Access Compliance Report

Public Rights-of-Way

Intersection ID: 49273	Main Street: REMINISCE_LN	Cross Street: REUNION_ST	Location: SE
ADA ID: D74655DE3BFB	Ramp Type: PerpDiag	Initial Pass/Fail: Pass	Overall Compliance: No
		Severity Score: 0

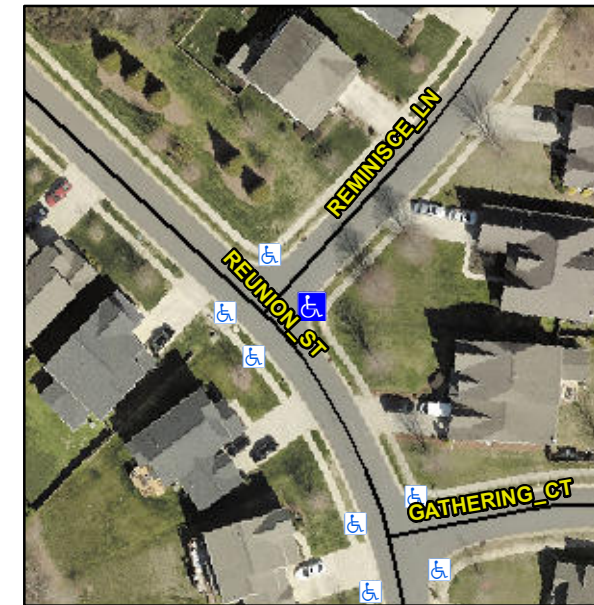
Not Found, R304.2.1, R304.2.2-Perp, R304.3.2-Para

Compliance	Description	Data	Compliance	Description	Data
N/A	Ramp Length (in)	48.5	Yes	Ramp Slope (%)	6.3
Yes	Ramp Width (in)	48.0	Yes	Ramp XSlope (%)	0.5
N/A	Flare Type LT	Sloped	N/A	Flare Type RT	N/A
N/A	Flare Slope LT (%)	2.5	Yes	Flare Slope RT (%)	1.6
N/A	Flare Traversable LT?	Yes	N/A	Flare Traversable RT?	Yes
No	Landing Length (in)	47.0	Yes	DWS Provided?	Yes
Yes	Landing Width (in)	48.0	Yes	DWS Contrast?	Yes
No	Landing Slope (%)	3.3	Yes	DWS Length (in)	24.5
Yes	Landing X Slope (%)	0.0	Yes	DWS Full Width?	Yes
N/A	Landing Curb? (Y/N)	No	Yes	DWS Offset (in)	2.0
N/A	Shared Landing?	No			
Yes	Gutter Ponding?	No	Yes	Gutter Slope (%)	0.5
Yes	Gutter Lip Ht (in)	0.0	Yes	Gutter X Slope (%)	1.6
N/A	Painted X Walk1?	No	N/A	Painted X Walk2?	No
	X Walk 1 Direction	To NW		X Walk 2 Direction	To SW
N/A	X Walk 1 Width (in)	N/A	N/A	X Walk 2 Width (in)	N/A
	X Walk 1 Slope (%)	3.1		X Walk 2 Slope (%)	4.4
	X Walk 1 X Slope (%)	2.8		X Walk 2 X Slope (%)	0.0

Remove & Replace Curb Ramp With Two New Directional Ramps or Equivalent.
